CHANGE ORDER

DATE:	June 8, 2022	CO #:01	One (1)
TO:	SES Roofing, LLC 1287 McClure Road Winchester, KY 40391	PROJECT:	Estill County ARP ESSER Stadium Restrooms Renovation Irvine, Kentucky BG# 22-243 RTA 2162
CONTRACT DATE:	April 18, 2022	CONTRACT FOR:	General Construction

DATE:	May 25, 2022	PR #:	01
TO:	SES, LLC 1287 McClure Road Winchester, KY 40391	RE:	Estill Co. High School ARP ESSER Field House Restroom Renovation Irvine, Kentucky BG 22-243 RTA 2162

ATTACHMENTS: PR1.1, PR1.2, PR1.3

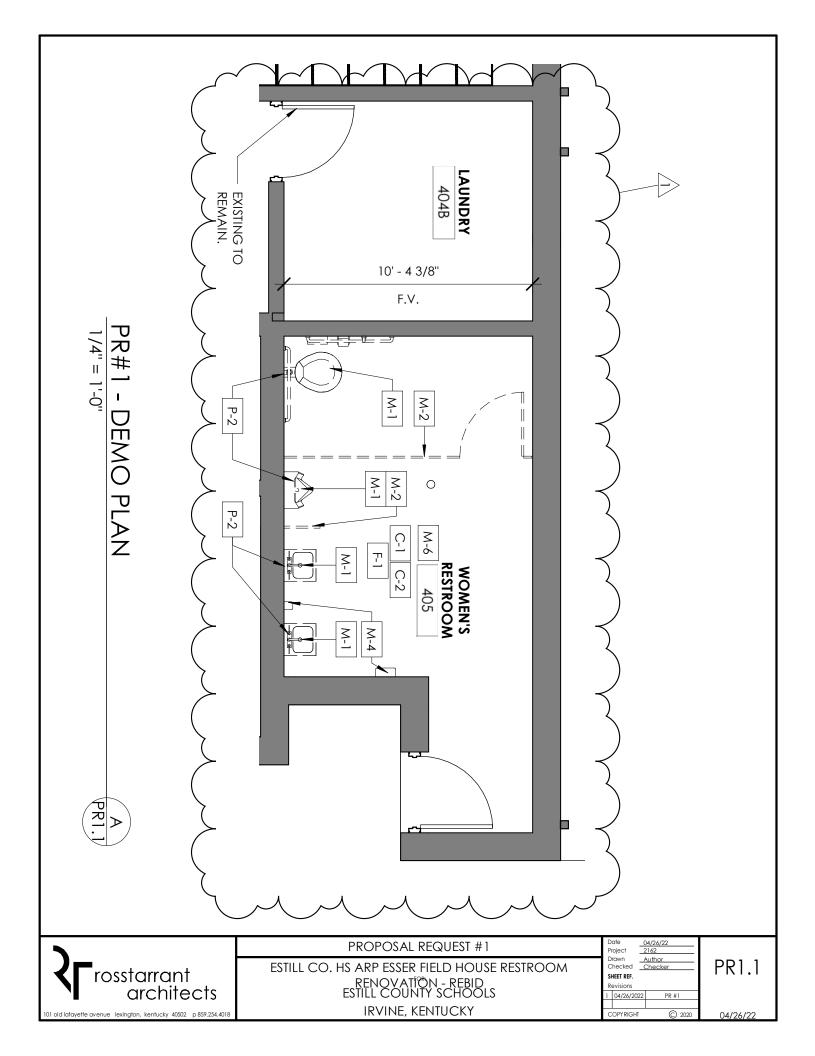
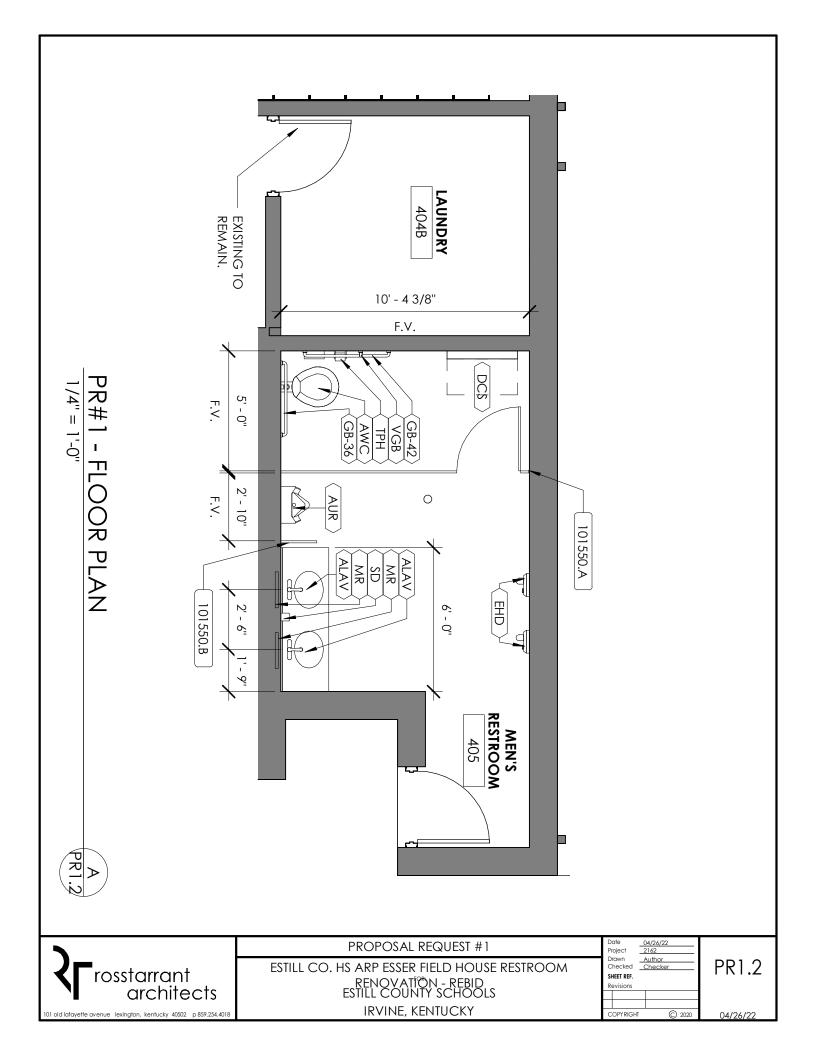
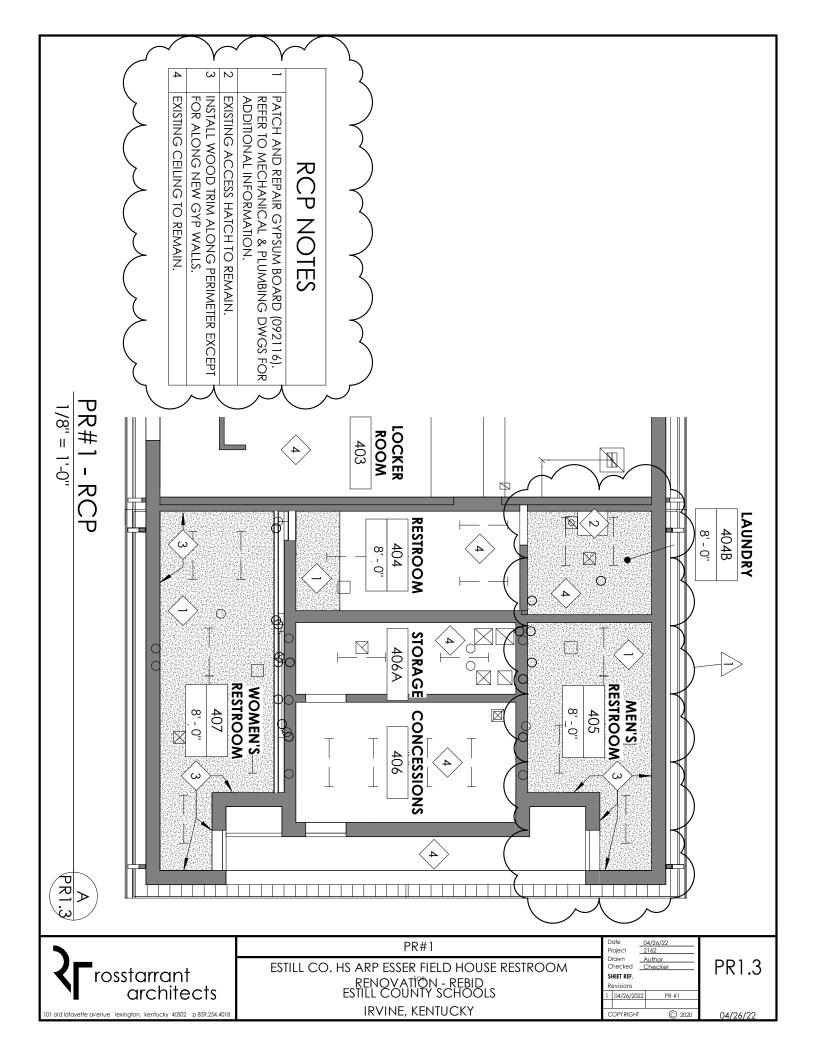
Refer to sheets D1.1 and A1.1 and revise Laundry Room 404B and Men's Restroom 405 as described below and shown on the attached sketches.

Refer to A2.1 and delete drawing detail C/A2.1. Revise drawing detail D/A2.1 to match the revised Men's Restroom intent for showing 1 Urinal in lieu of 2 within the existing room.

- 1. The floor finish within both restrooms is to become Ceramic Tile in lieu of Flake Epoxy.
- 2. Laundry Room 404B scope reduction:
 - 1. Delete all demolition scope within room
 - 2. Delete mop sink installation and mop broom hanger scope
 - 3. Delete washer/dryer installation and penetrations scope
 - 4. Delete wall demolition and new wall construction with smoke rating scope
 - 5. Delete door 404B new frame, door, and hardware scope
 - 6. Delete ceiling patching and new trim scope
 - 7. Refer to CMTA attachment MEP scope reduction.
- 3. Men's Restroom 405 scope reduction:
 - 1. Refer to PR1.1 for demolition scope
 - 2. Delete new chase wall scope
 - 3. Delete additional urinal and urinal partition installation
 - 4. Refer to CMTA attachment MEP scope reduction.
